SERVICE LETTER

N^o 16/63

To: Owners and Operators of BÖLKOW JUNIOR
BO 208 A2 and A3

Subject: Inspection and Replacement of Main Landing Gear
Attachment Brackets

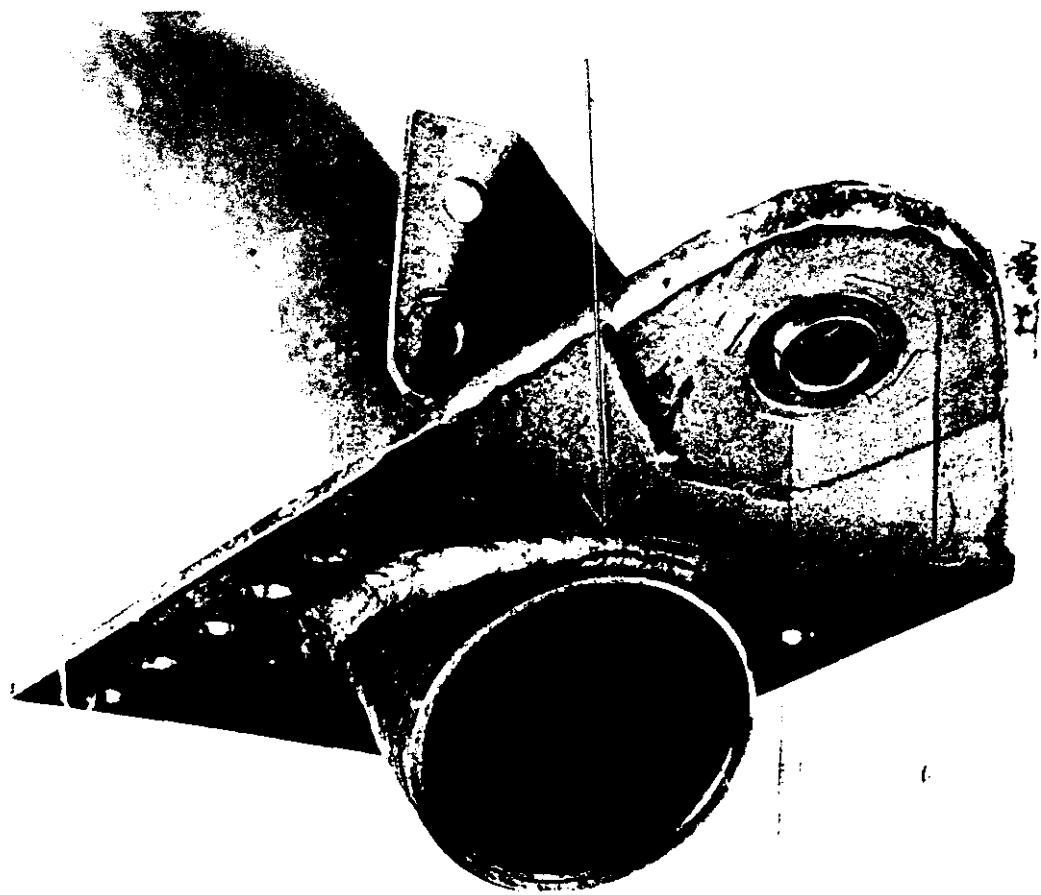
Als Sofortmaßnahme bitten wir Sie, die Beschläge an beiden Seiten des Rumpfes vor jedem Fluge daraufhin zu untersuchen, ob sich an der, auf beiliegendem Foto durch einen Pfeil gekennzeichneten Stelle, Risse gebildet haben.

Sollten sich Risse zeigen, darf die Maschine nicht mehr geflogen werden. Setzen Sie sich in diesem Falle bitte mit Herrn Klier, Werk Laupheim, Telefon (07392) 750 und 751, Telex 07 127 46, in Verbindung.

As an immediate precaution, we strongly recommend inspecting the attachment brackets on both sides of the fuselage for possible cracks in the designated areas prior to each flight, as illustrated in the attached photograph.

The airplane must not be flown, if cracks are evident. For advice please contact our Service Manager Mr. Klier at the Laupheim plant. Tel. (07392) 750 or 751, Telex 07 12 746.

Infolge eines Materialfehlers hat sich leider die Notwendigkeit ergeben, die Hauptfahrwerk-Anschlußbeschläge - selbstverständlich kostenlos - gegen neue auszutauschen. Wir werden Sie daher in absehbarer Zeit bitten, zu diesem Zweck Ihr Flugzeug zu der Ihnen nächstgelegenen Service-Stelle oder in unser Werk Laupheim zu bringen.

Due to a material failure it has become necessary to replace the main landing gear attachment brackets - this service will be performed at no extra cost -. We shall call upon you in the near future, to bring your airplane to the nearest service installation or to our Laupheim manufacturing plant to correct this condition.
